Blocking of unintentional starter motor engagement

111 170

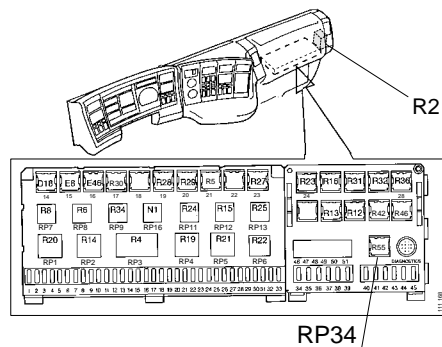
The cause of these problems is that the starter motor is engaged while the engine is running. One reason for this may be that the driver tries to start the engine when it is already running. Another reason may be that the driver turns the ignition key to starting position while driving.

The problem is solved by fitting a protective circuit in the central electric unit. The circuit prevents the starter motor from being engaged while the engine is running.

1. Disconnect vehicle power supply by disconnecting battery negative lead or by switching off main power switch.
2. Remove cover below central electric unit. Open central electric unit.

3. Insert cable harness 1 422 862 according to wiring diagram.
4. If required, detach R2 from mounting plate or remove the nearest control unit. If vehicle is fitted with VPS (Vehicle Protection System), remove VPS battery. Refer to illustration above for component location.

5. Detach cable 50X.VT-1,5 from relay R2-86. R2 is fitted to underside of mounting plate, below central electric unit. Remove existing cable terminal from cable by cutting. Strip cable as required and crimp on cable terminal 815 699. Insert cable terminal into new connector marked C 5001.

6. Detach cable from R2-87 (50.Wh-4). Fit cable with ring terminal 50.WH-1 in cable harness 1 422 862 to R2-87. Position new ring terminal lowermost and refit detached cables on top.
